RYLANDS BUILDING MANCHESTER

PROPOSED DESIGN AMENDMENTS

October 2024

The purpose of this document is to provide supporting information to the amendment applications for Rylands Building, Manchester.

ELEVATION C - NORTH

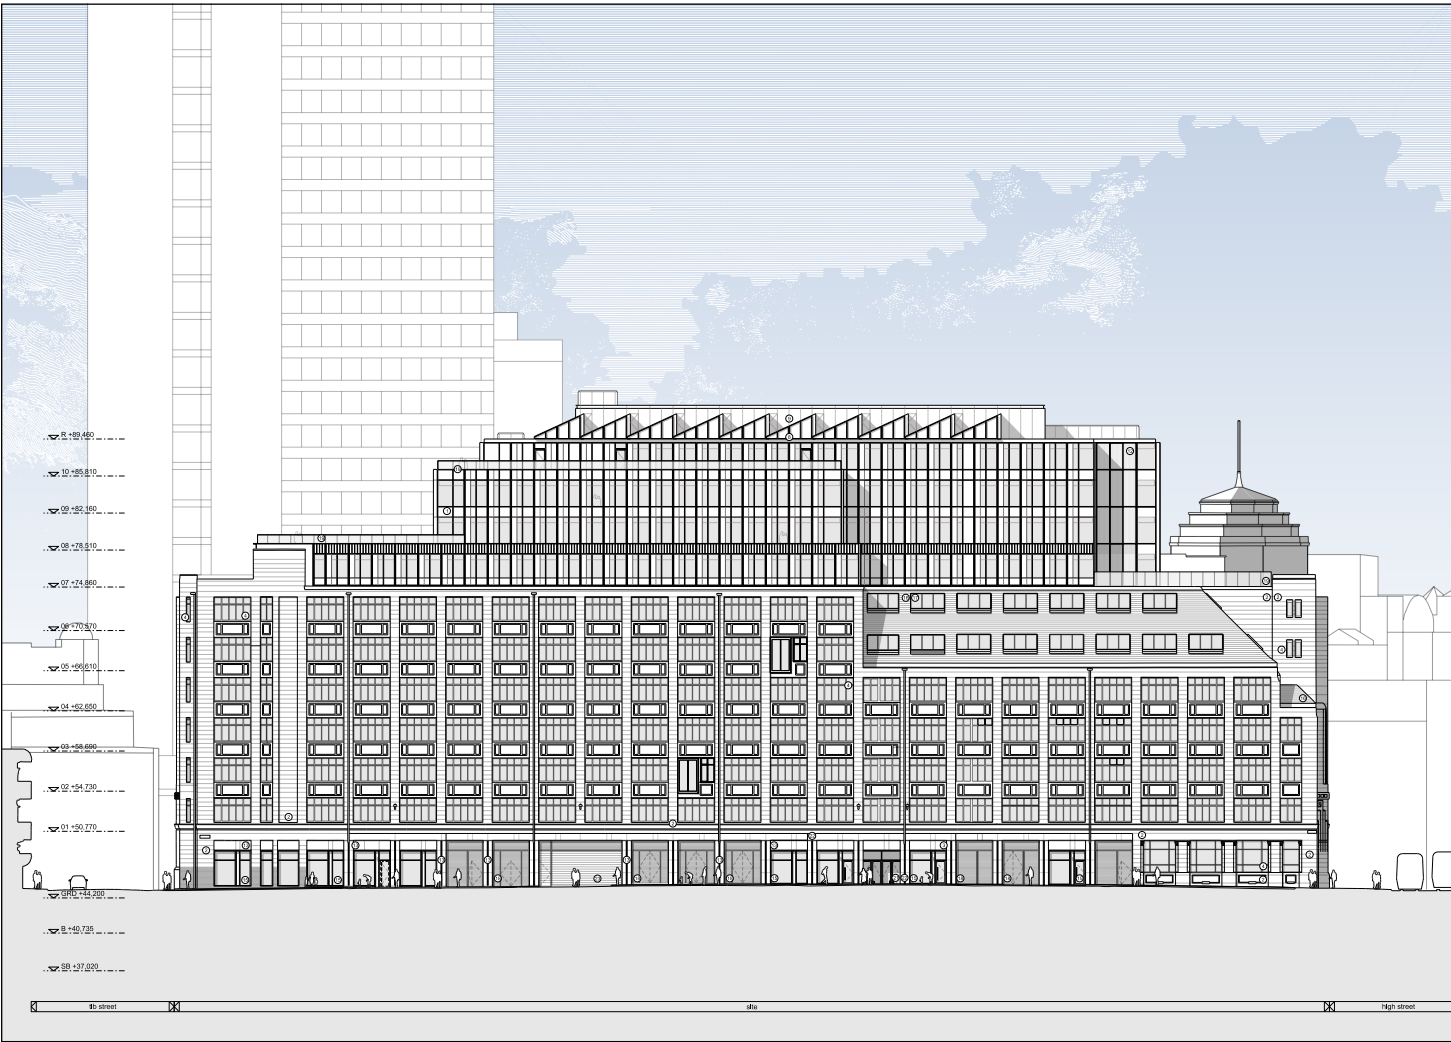
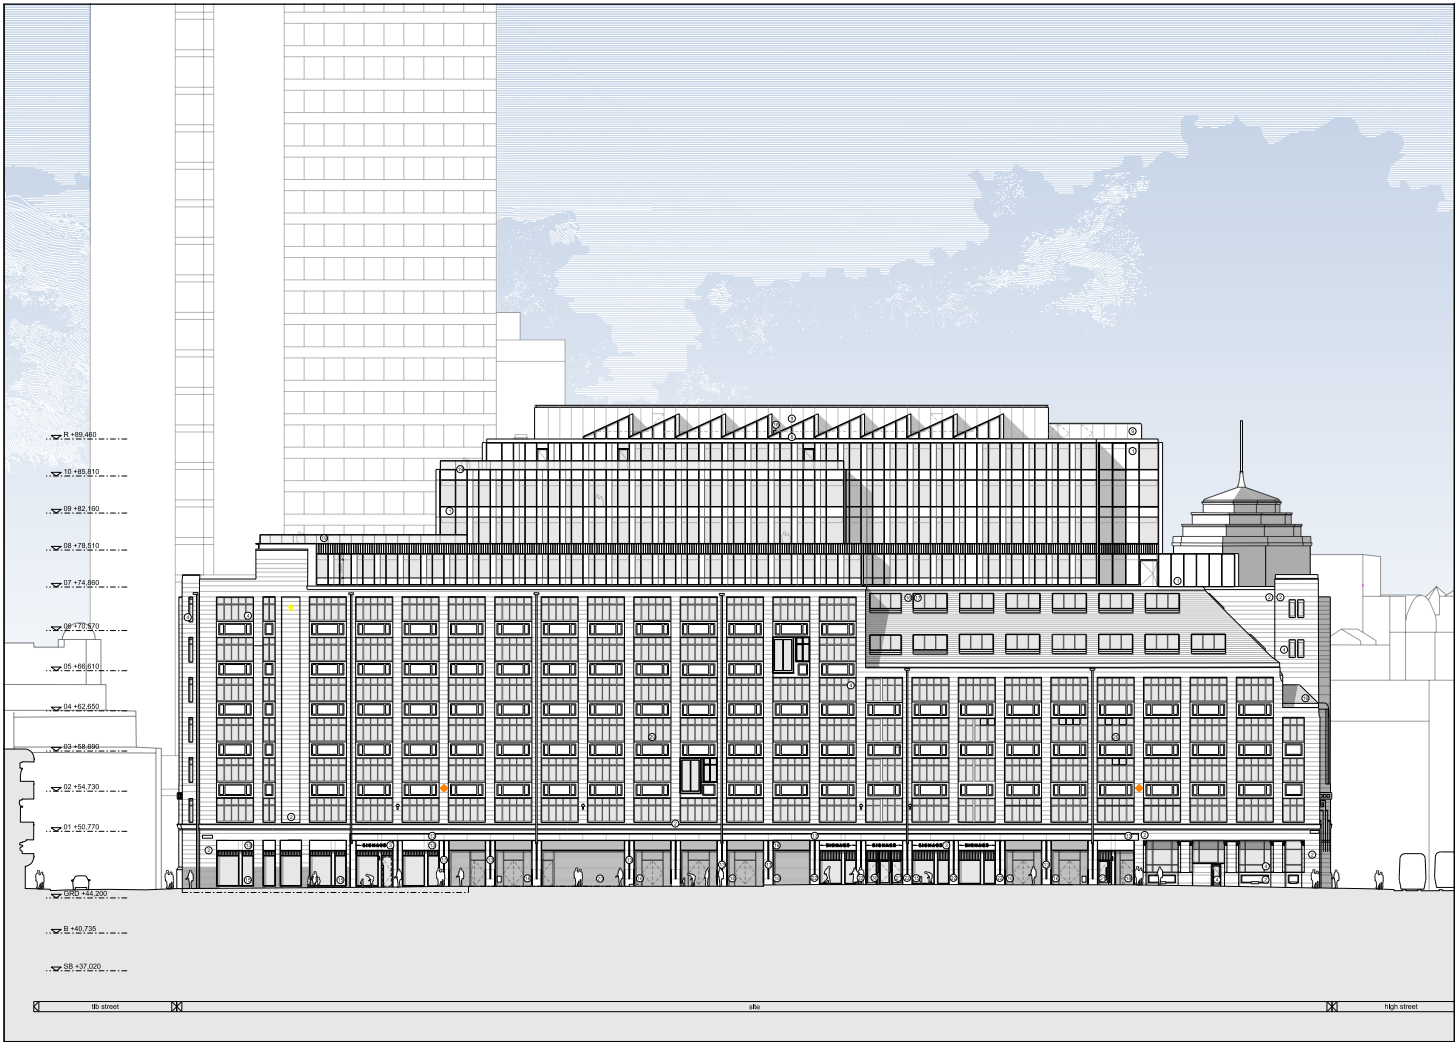
| GROUND FLOOR SHOP UNITS | LEVEL 11 PLANT SPACE |
| LEVEL 07 PLANT SPACE | REMOVAL OF LEVEL 07 BALUSTRADE |
| UCW CLADDING AMENDMENT | SHOP FRONT UPDATES |

ELEVATION D - WEST

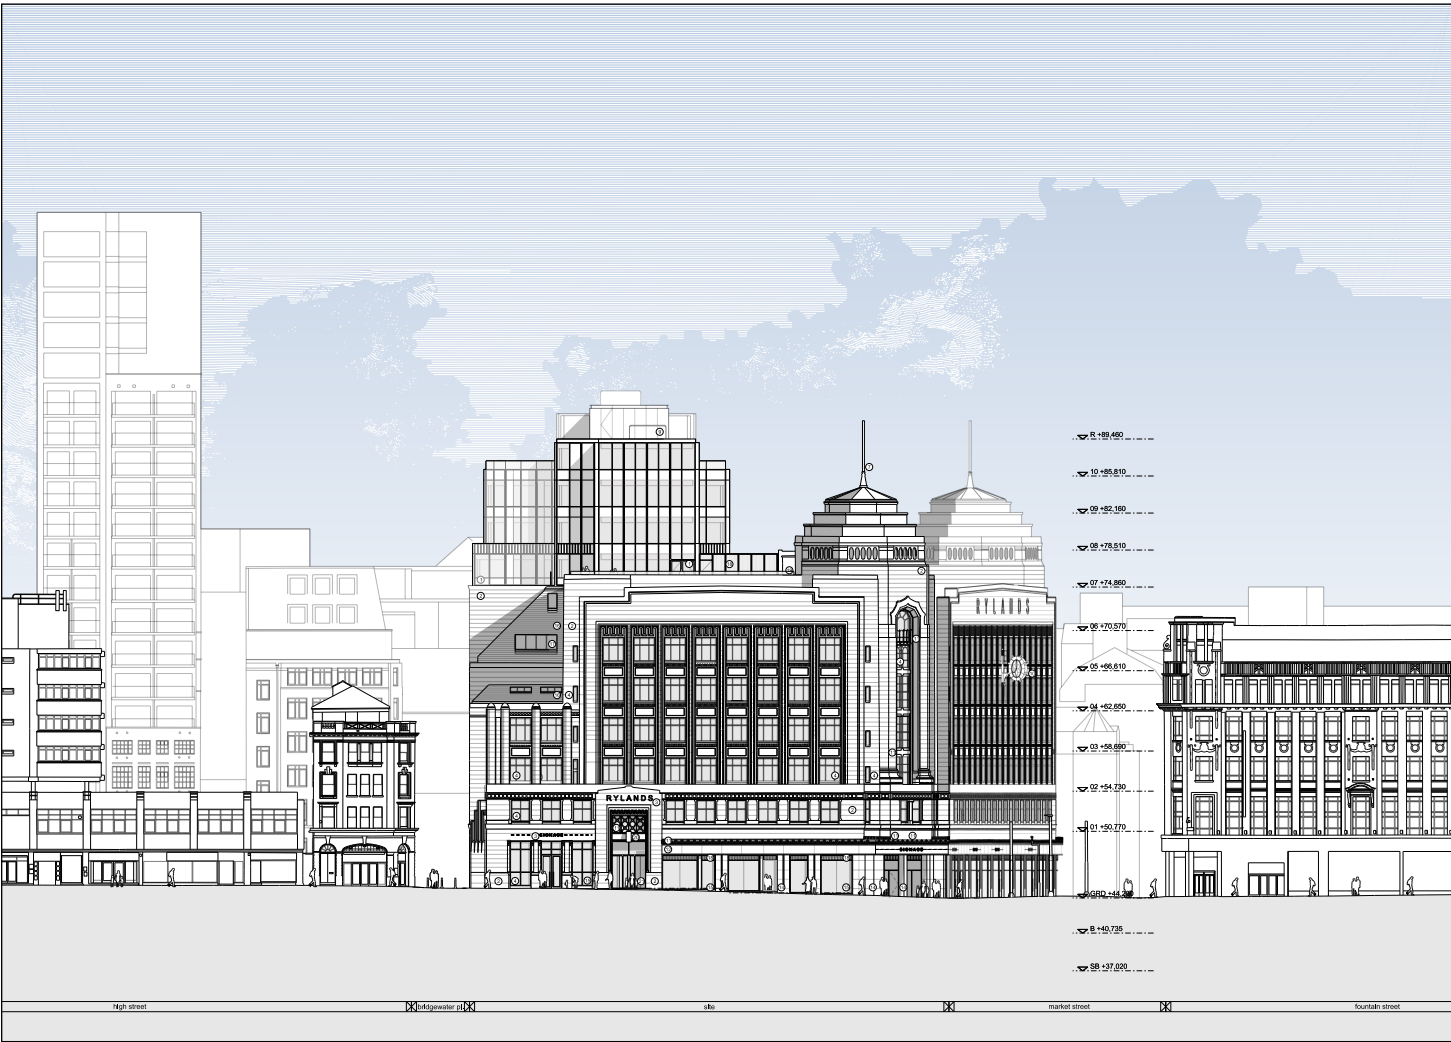
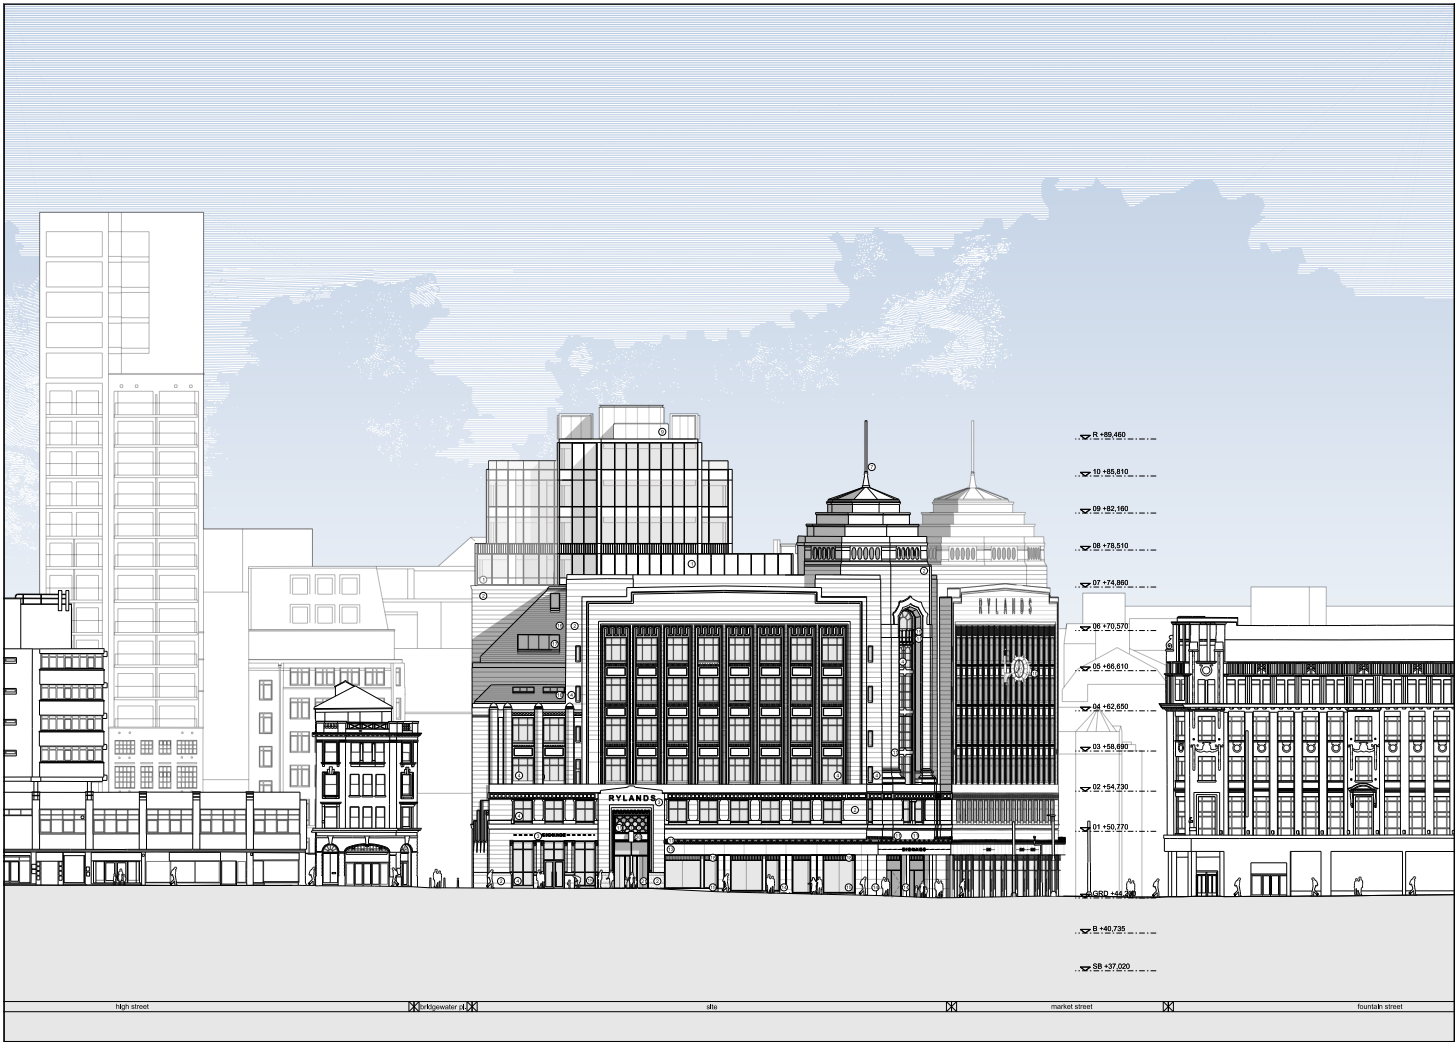
- LEVEL 07 PLANT SPACE
- LEVEL 11 PLANT SPACE
- UCW CLADDING AMENDMENT
- SAWTOOTH ROOF DETAILING
- GROUND FLOOR SHOP UNITS
